UNITED STATES PATENT AND TRADEMARK OFFICE

APPLICATION NO.	FILING DATE	FIRST NAMED INVENTOR	ATTORNEY DOCKET NO.	CONFIRMATION NO.
10/811,464	03/26/2004	Richard Hai Huang	SAR100064000	1785
22891	7590	07/27/2005	EXAMINER	
DELIO & PETERSON 121 WHITNEY AVENUE NEW HAVEN, CT 06510			LUGO, CARLOS	
			ART UNIT	PAPER NUMBER
			3676

Office Action Summary

DETAILED ACTION

FIG.3

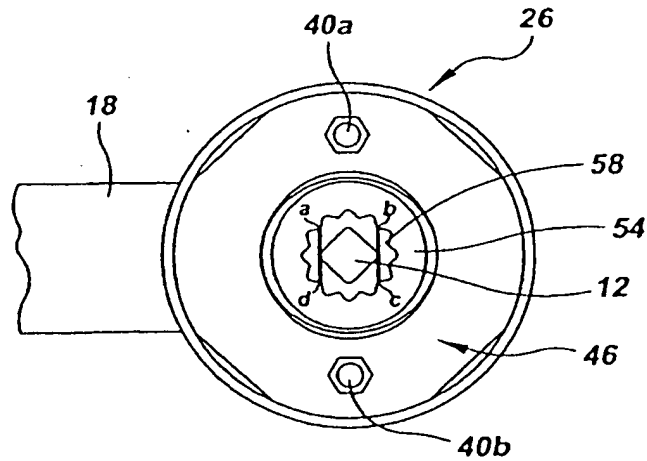
1. The drawings are objected to because:
 - In Figure 2, change "10" to -18-.
 - In Figure 3, clearly illustrates the spindle 12 (see attachment #1 point A).

FIG.4

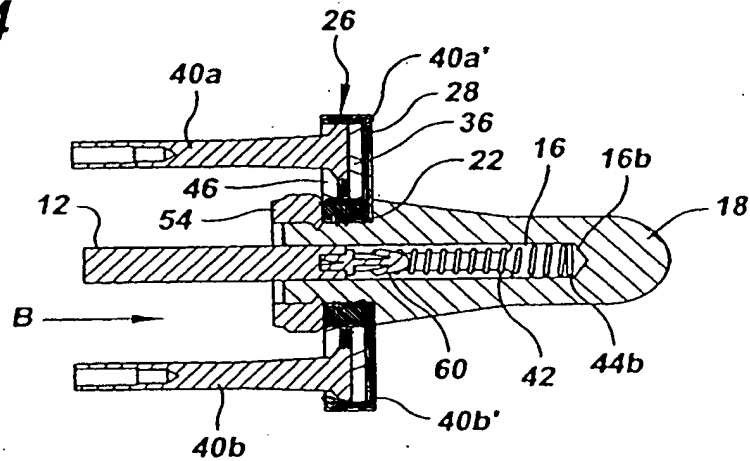
- In Figures 4 and 5, clearly define the mounting plate and the mounting posts with appropriate cross-hatching. The current drawings show that the mounting posts and the mounting plate are a one-piece embodiment when they are separate members connected together (see attachment #1 point B).

- In Figure 4, change the pointing line position of element 40b' (see attachment #1).
 - In Figure 5, change the pointing line position of element 48' (see attachment #1).

As seen in Figure 4, see attachment #2, the cover 26 has a lip 34 and the mounting plate 46 also has a lip 48. The lip 48 is located over the lip 34; therefore, the cover lip 34 has external threads that threadedly engage inner threads at the mounting lip 48.
